PIC16C74A Rev. A Silicon Errata Sheet

The PIC16C74A (Rev. A) parts you have received conform functionally to the Device Data Sheet (DS30390E), except for the anomalies described below.

Clarifications/Corrections to the Data Sheet:

FIGURE 1: SCK PULSE VARIATION USING TIMER2/2

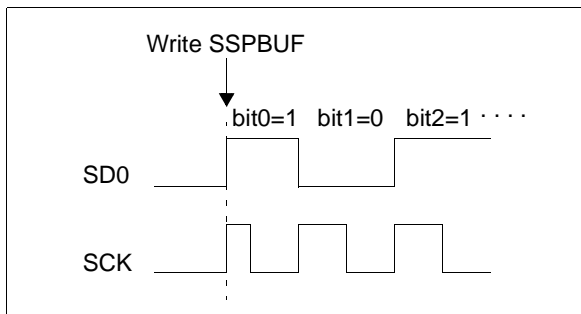
When the SPI is using Timer2/2 as the clock source, a shorter than expected SCK pulse may occur on the first bit of the transmitted/received data (Figure 1).

To avoid producing the short pulse, turn off Timer2 and clear the TMR2 register, load the SSPBUF with the data to transmit, and then turn Timer2 back on. Refer to Example 1 for sample code.

FIGURE 1: WRITES TO TIMER1 (EXTERNAL CLOCK/OSCILLATOR MODE)

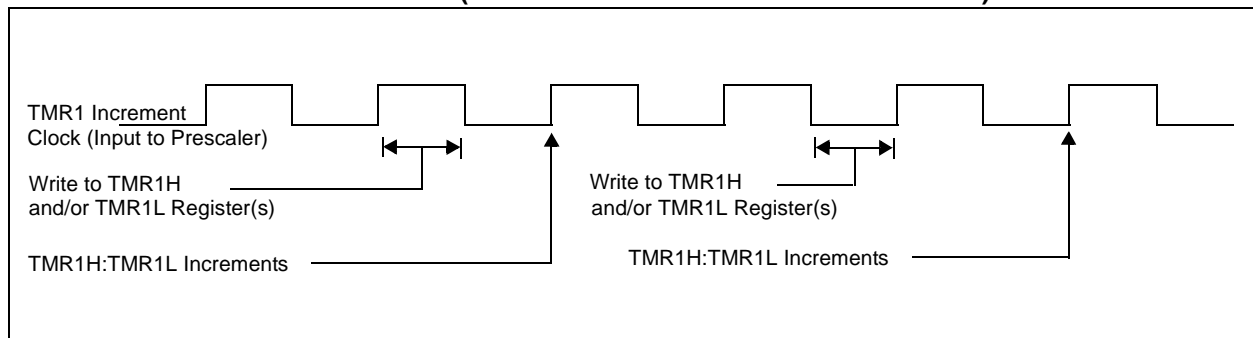
The operation of Timer1 needs some clarification when the timer registers are written when the TMR1ON bit is set.

The internal clock signal that is the input to the TMR1 prescaler affects the incrementing of Timer1 (TMR1H:TMR1L registers and the Timer1 prescaler). When the Timer1 registers are NOT written, the Timer1 will increment on the rising edge of the TMR1 increment clock.

When the TMR1H and/or TMR1L registers are written while this clock is high, TMR1 will increment on the next rising edge of this clock.

When the TMR1H and/or TMR1L registers are written while this clock is low, TMR1 will not increment on the next rising edge of this clock, but must first have a falling clock and the rising clock, for TMR1 to increment.

Figure 1 shows the two cases of writes to the TMR1H and/or TMR1L registers. Due to the V_{IH} and V_{IL} thresholds on the oscillator/clock pins, external Timer1 oscillator components, and external clock frequency, the Timer1 increment clock may not be of a 50% duty cycle.

The TMR1 increment clock is out of phase of the T1OSO/T1CKI pin by a small propagation delay.
